Covering Note - Response to NatureScot Points (a) and (b) – River Moriston SAC

1.1 On 19 January 2026, NatureScot submitted a further updated consultation response in respect of the application for section 36 consent and deemed planning permission for the Glen Earrach Pumped Storage Hydro Scheme (the 'Application'). The NatureScot response related specifically to impacts on the River Moriston Special Area of Conservation ('SAC'). It identified five areas on which NatureScot wished to receive further information listed as items (a) to (e) relating to the SAC.

Appendix A – Responses to Points Raised by NatureScot in its Response of 25 February 2026

01 Phase 1 - Form Smolt Passes 1 & 2
0103 NTS

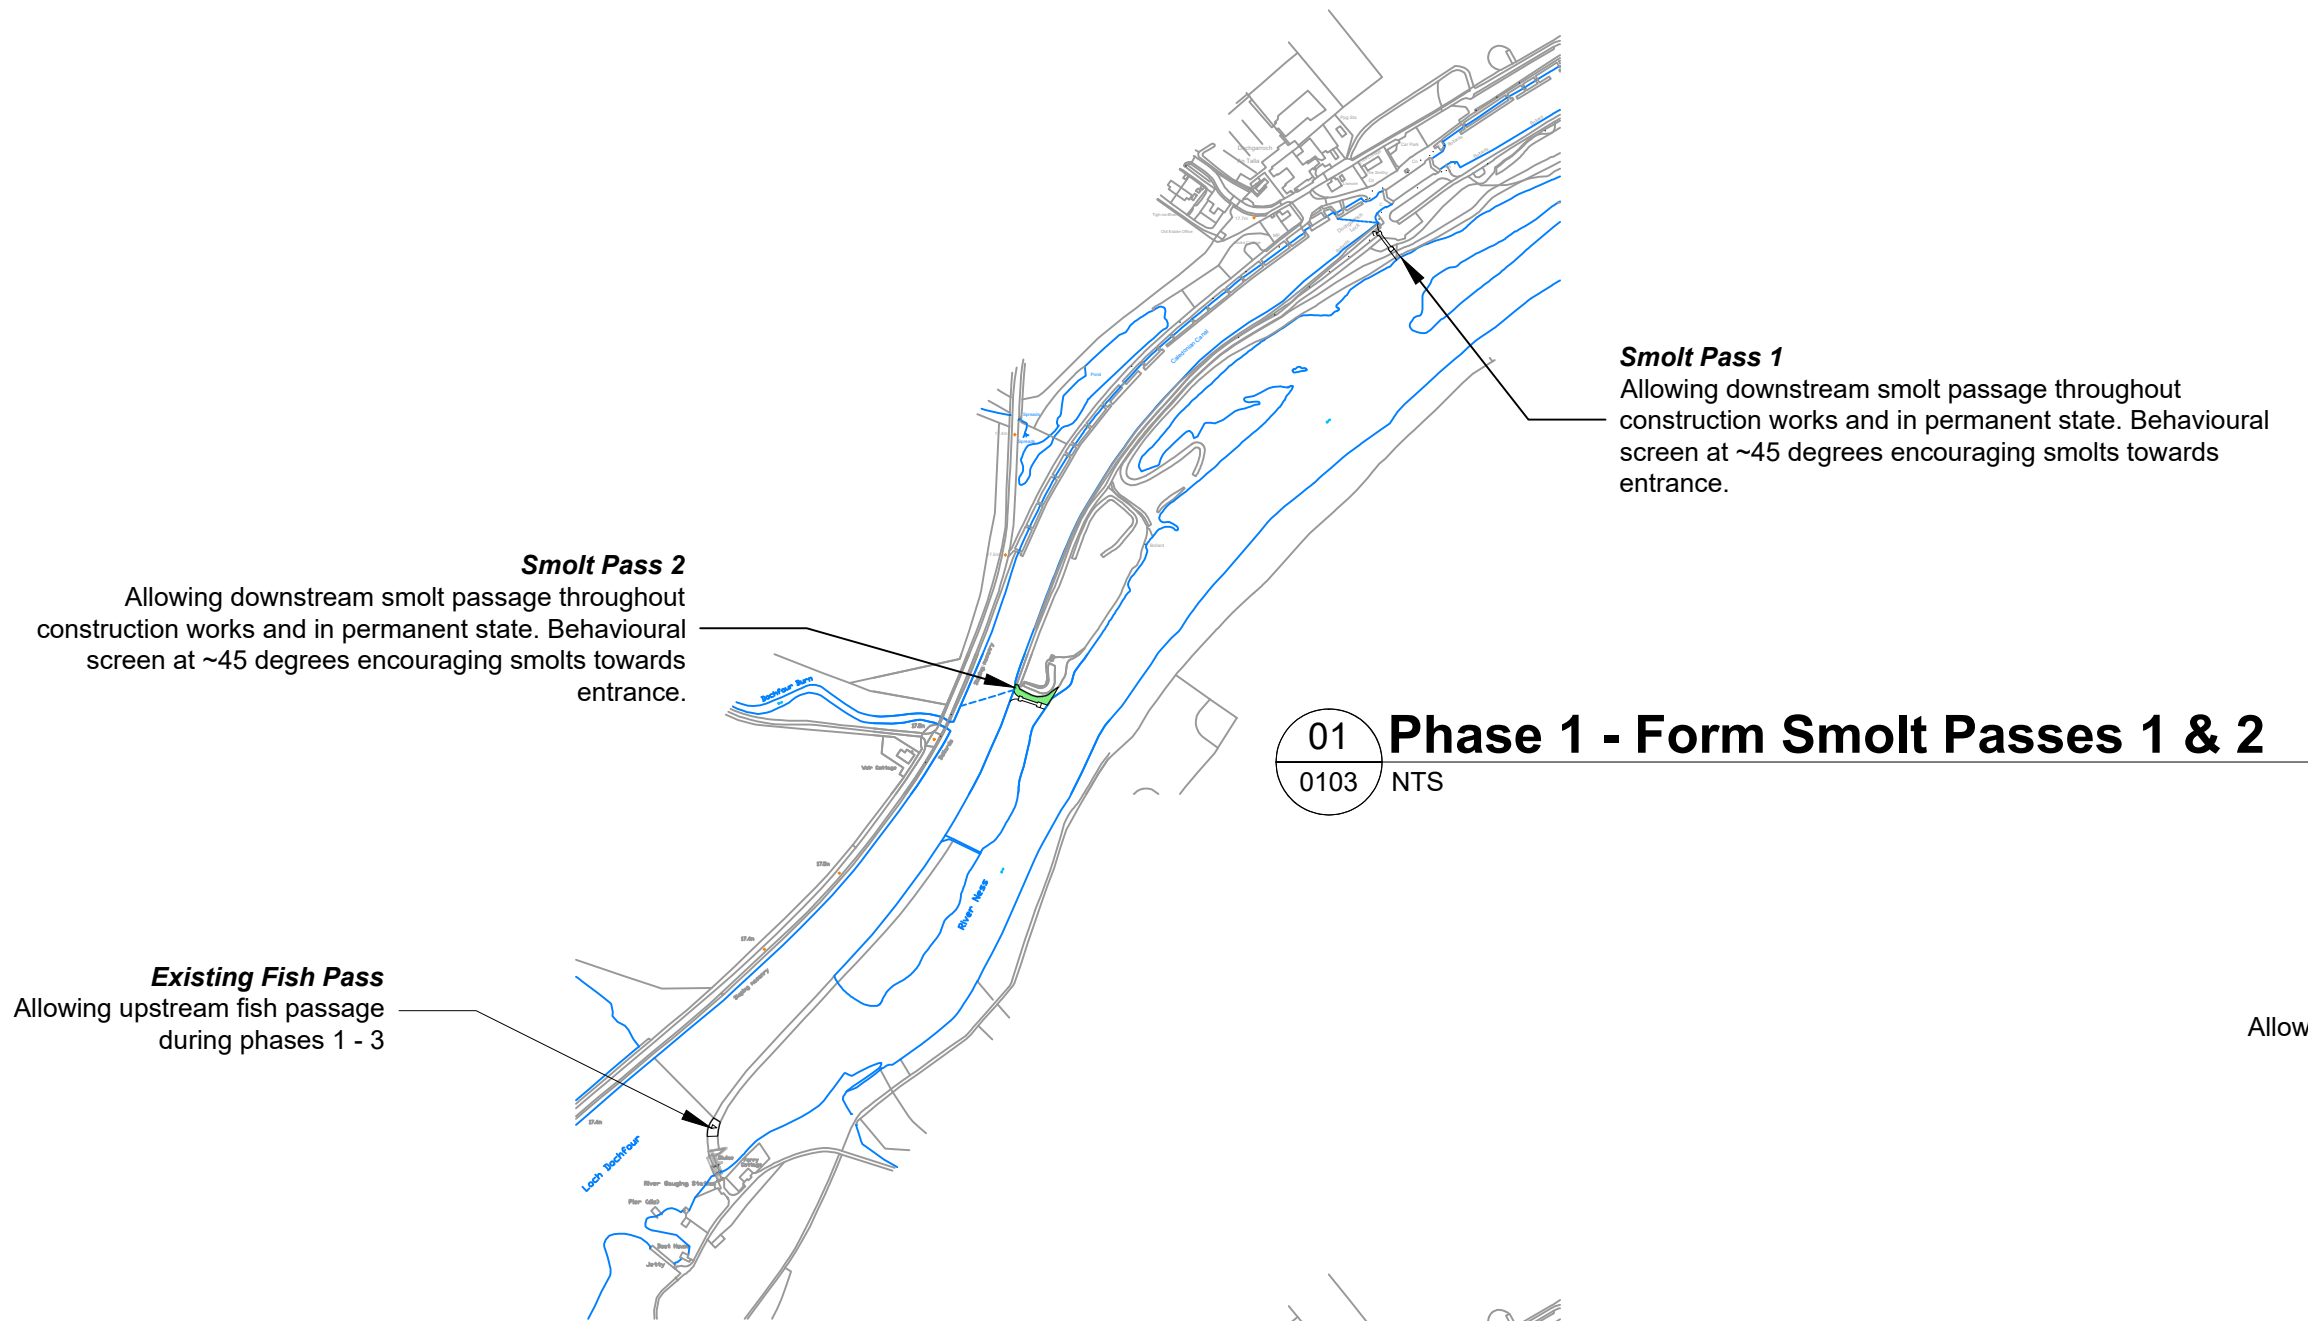
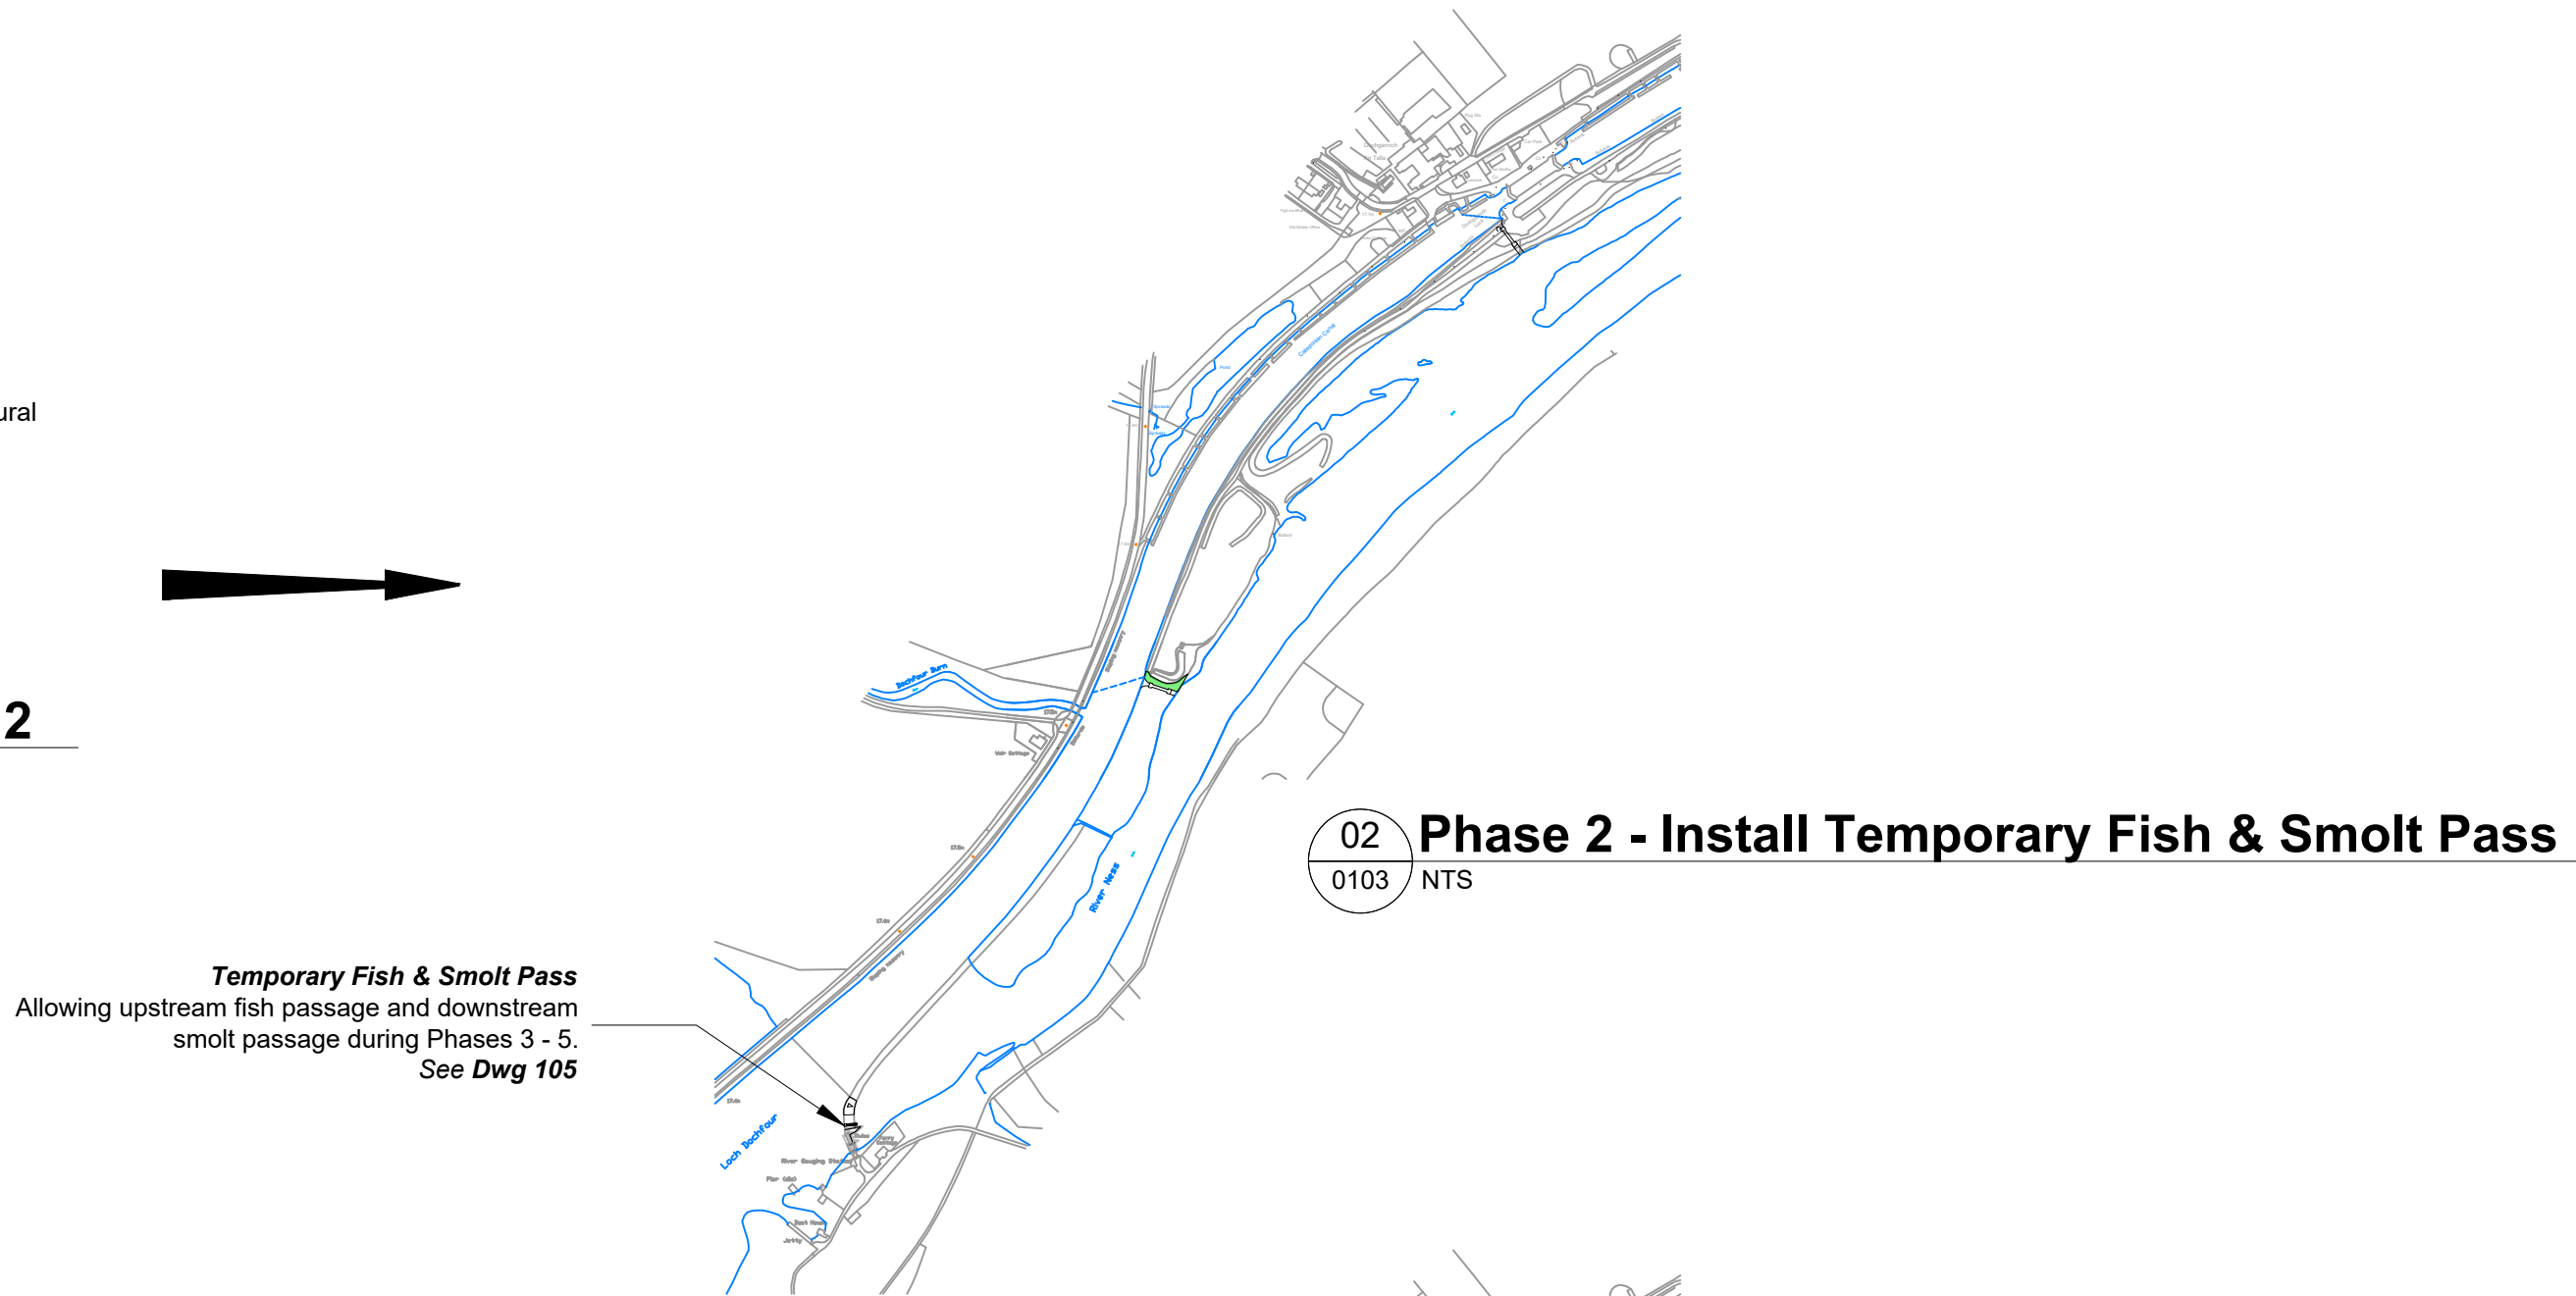
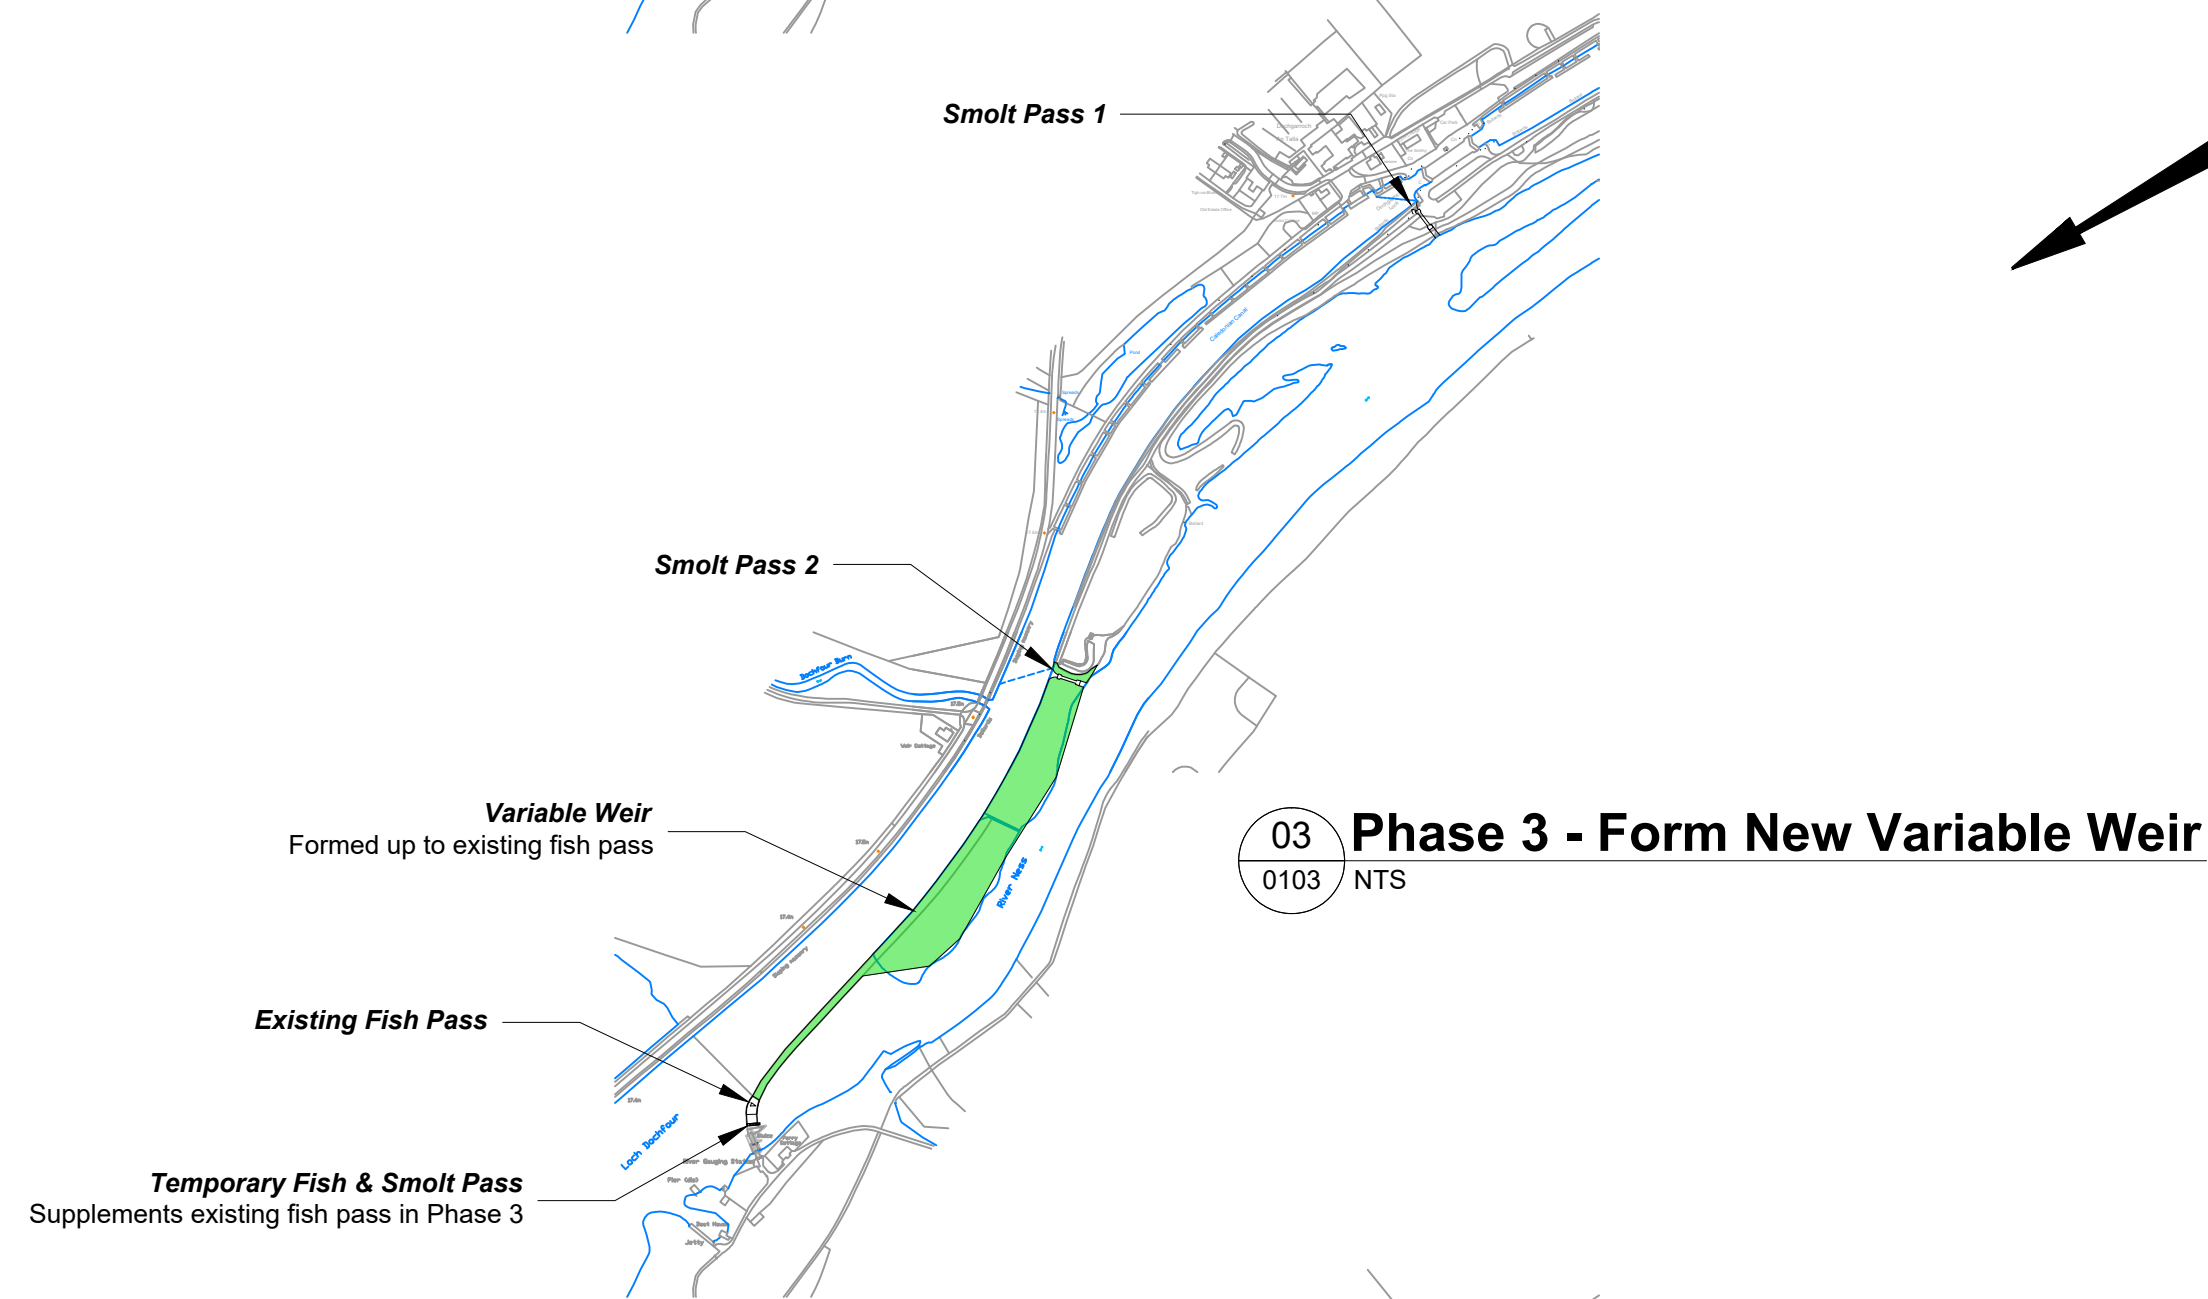
- to demonstrate that the proposed temporary Alaskan Denil pass will be passable by Atlantic salmon throughout the construction period. Evidence should explicitly draw on published guidance and research to detail each parameter (eg attractant flows, velocities, water depths) that needs to be considered in the design to ensure salmon passage; the range of values the fish pass will be designed to deliver for each parameter; and justify why these have been selected in relation to those recommended in the literature.

Applicant response: Temporary Fish Passage Technical Note v1.3 now includes further detail on the flow volumes and hydraulic operation of the temporary fish passage elements. The construction sequencing drawing 0103-3540681-P03 now includes clear detail how upstream and downstream passage will be maintained through the construction phase. The continuity of passage is also described in detail in the specific note Construction Disturbance and Fish Passage Continuity at Dochfour Weir.
